ORIGINATION FORM

Proposed Revisions to a Standard Plans Index
(Please provide all information — Incomplete forms will be returned)

Index Number: 521-660
Sheet Number (s): Sheets 1-4 of 4
Index Title: Light Pole Pedestal - Bridge

An option was included to allow for slip forming of the traffic barrier at the pedestal location. A gap was included between the barrier and pedestal to facilitate this.

(Without Raised Sidewalk shown, with Raised Sidewalk similar)
LIGHT POLE PEDESTAL FOR APPROACH SLAB OR BRIDGE DECK THICKNESS LESS THAN 1'-5 1/2" AT COPING

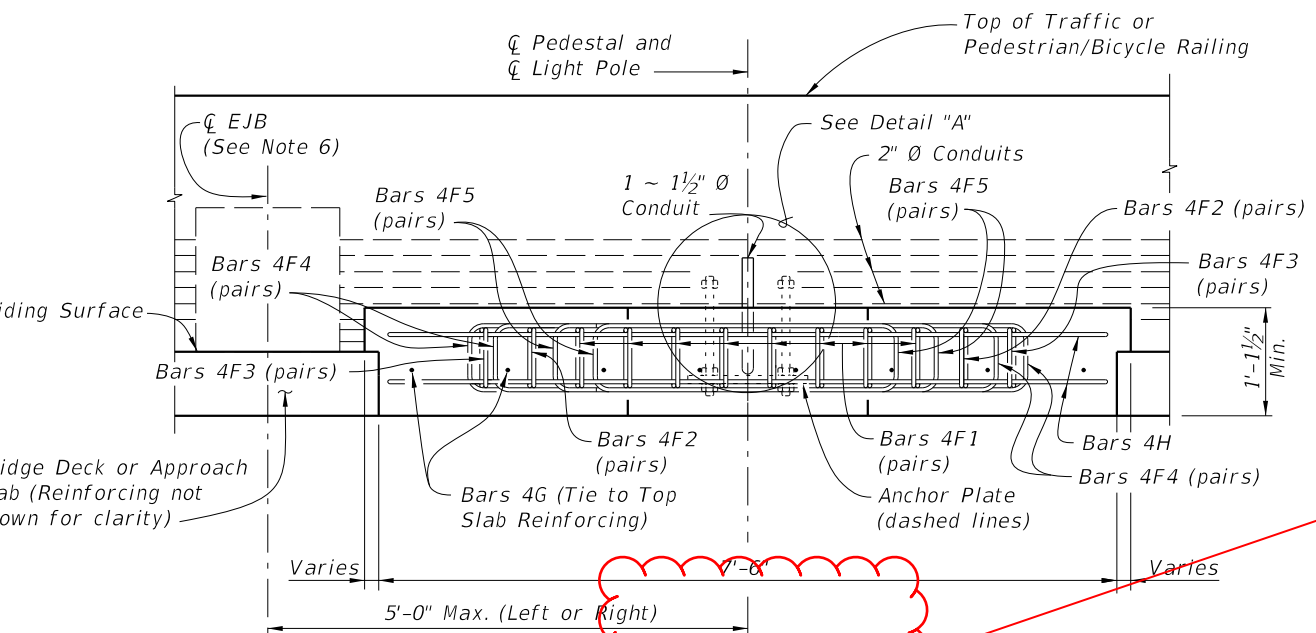
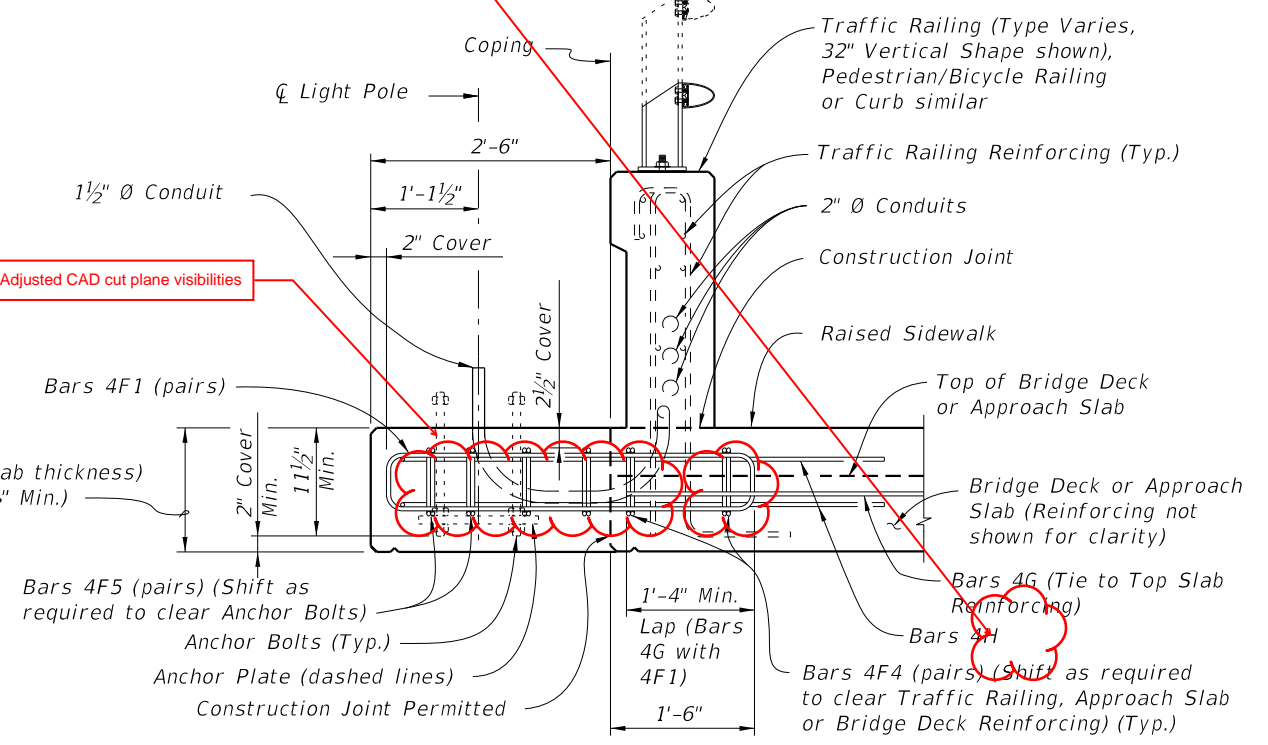
Adjusted CAD cut plane visibilities

Added clarifying language

CONVENTIONAL REINFORCING STEEL BENDING DIAGRAMS

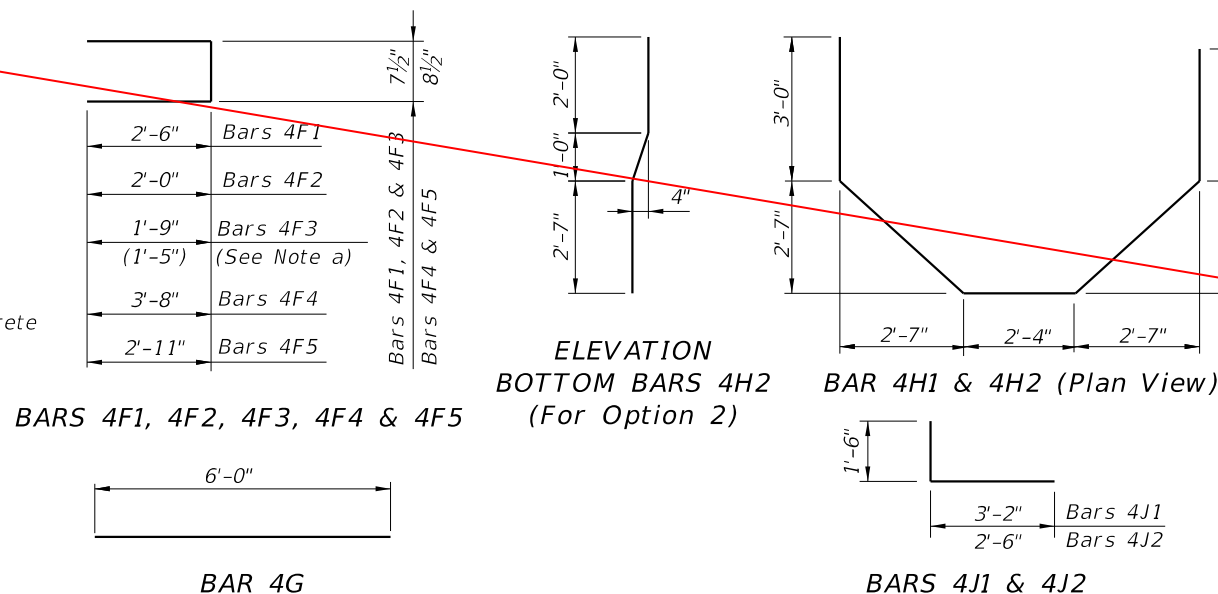
Reworked bar list to fit in new option

MARK	SIZE	NO. REQD.	LENGTH	NOTES
F1	4	16	5'-8"	c
F2	4	4	4'-8"	c
F3	4	4	4'-2" (3'-6")	a, c
F4	4	8 (6) [4 for Option 3]	8'-9"	b, c
F5	4	4	6'-9"	c
F6	4	4	2'-11"	-
F7	4	4	3'-8"	-
F8	4	12	4'-4"	-
G	4	8 [5 for Option 3] [24 for Option 3]	6'-0"	-
H1	4	2	15'-8"	-
H2	4	2	13'-10"	-
J1	4	8	4'-8"	d
J2	4	12	4'-0"	d

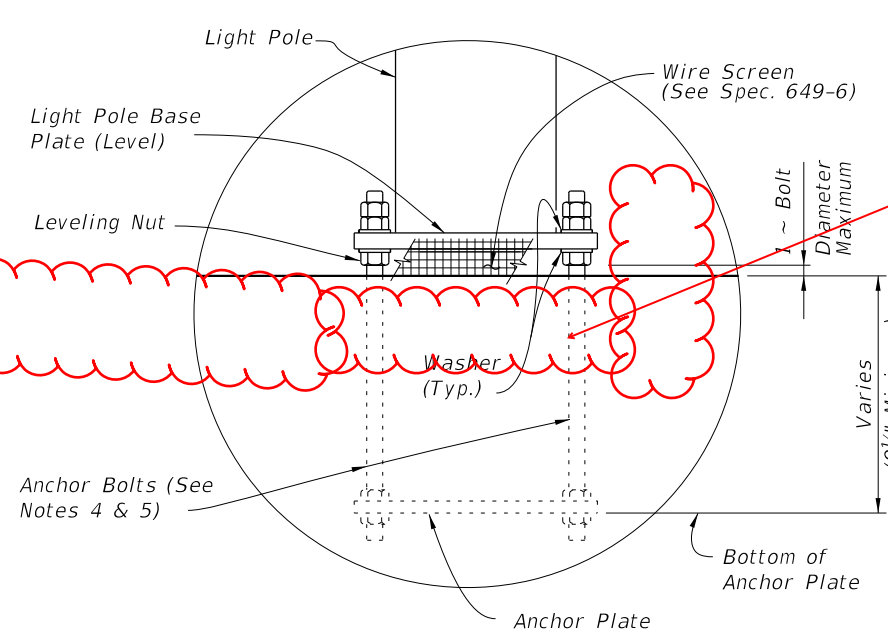
Added anchor nut for bottom of pedestal anchor breakout

OPTION 3 - PLAN VIEW WITH GAP BETWEEN BARRIER AND PEDESTAL TO ALLOW SLIP FORMING

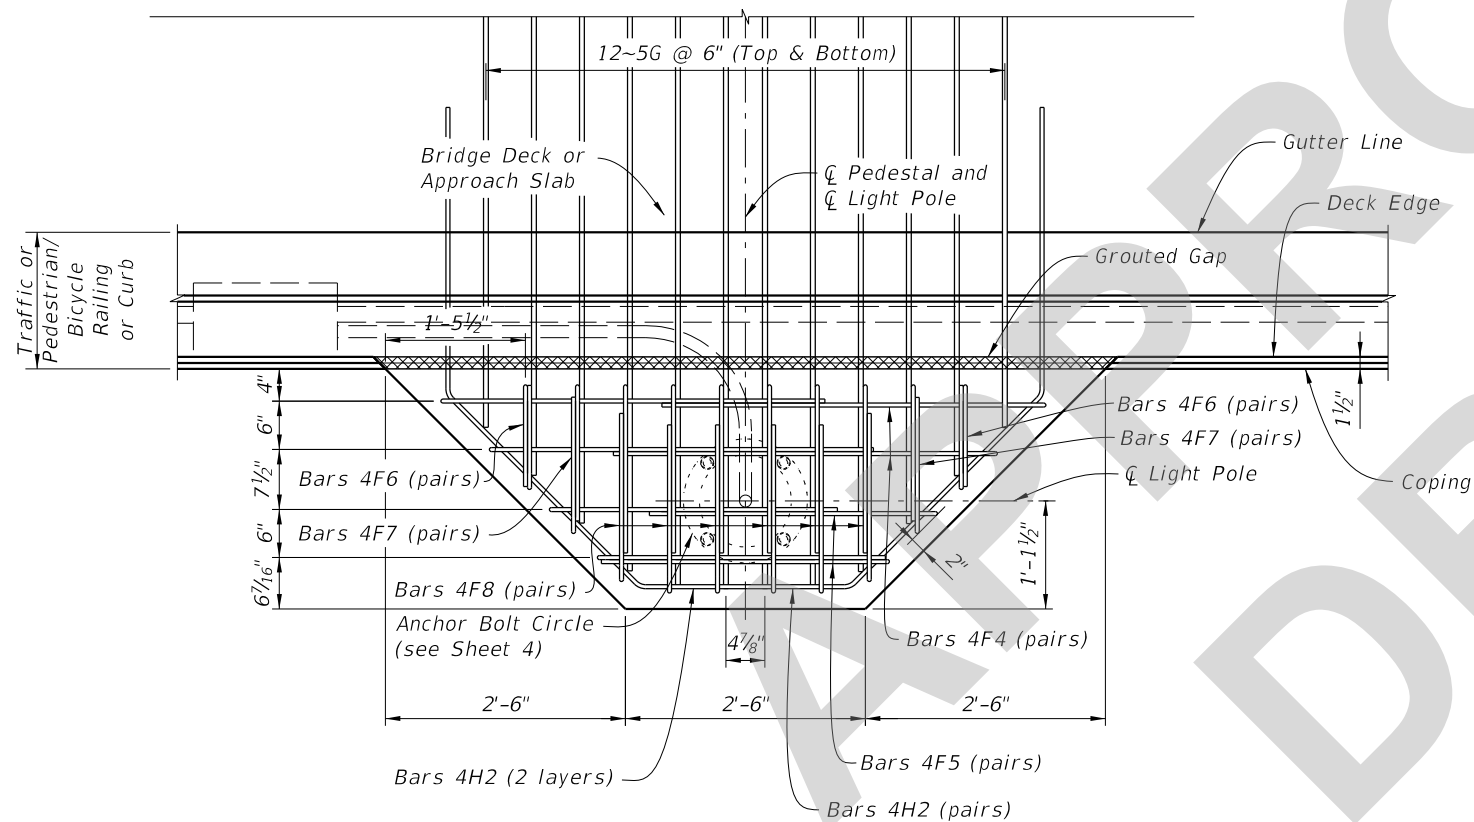
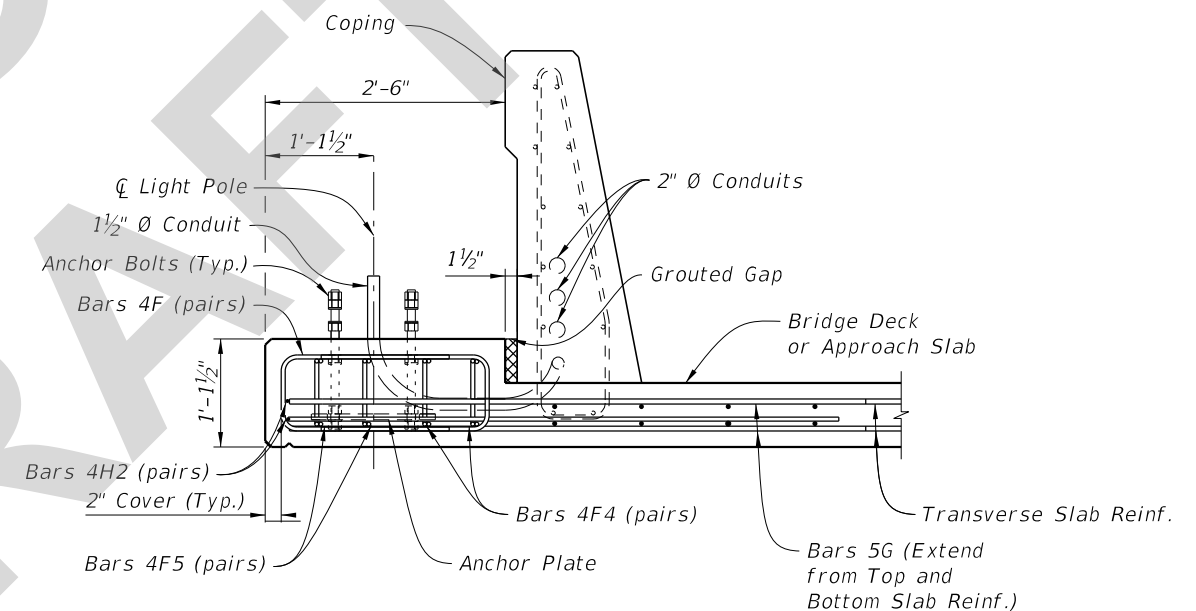
Contractor request in order to save time and materials required to form barrier separately at light pedestal locations.

OPTION 3 - TYPICAL SECTION AT LIGHT POLE PEDESTAL WITH GAP BETWEEN BARRIER AND PEDESTAL TO ALLOW SLIP FORMING
